**SUBJECT:** Contra Costa Power Plant Unit 8 (00-AFC-1C)

Revised Staff Analysis of the proposed addition of PG&E as an owner, extension of the construction milestones, and four facility enhancements

# REVISED STAFF ANALYSIS CONTRA COSTA POWER PLANT UNIT 8 (00-AFC-1C)

Location of the Contra Costa Power Plant and Proposed Project

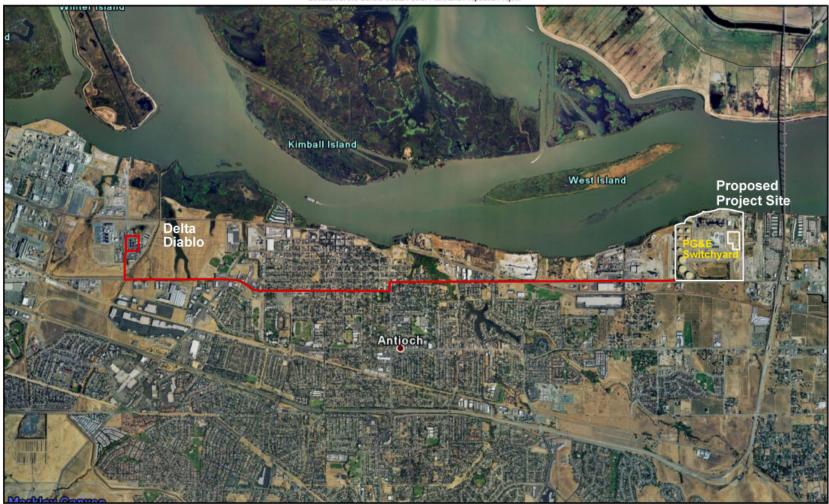
The CEC biological staff reviewed the database of known biological resources, and no fatal-flaws were identified with the construction of a 3-mile system to provide reclaimed water to the Contra Costa Power Plant Unit 8 and return the effluent to the treatment facility. There are no biological impacts identified with the operation of the proposed reclaimed water and effluent return pipelines. The following species have a potential to occur in the proposed project area (level noted after species) and could be impacted directly or indirectly by construction, dependent on the construction route, schedule and methodology:

In summary, it is staff's opinion that the use of reclaimed water from the Delta Diablo Wastewater Treatment Plant is a potentially viable alternative to the use of once-through cooling effluent for the operation of Contra Costa Power Plant Unit 8, and that suitable mitigation measures could be developed for any impacts to these species due to the construction of the reclaimed water pipeline.
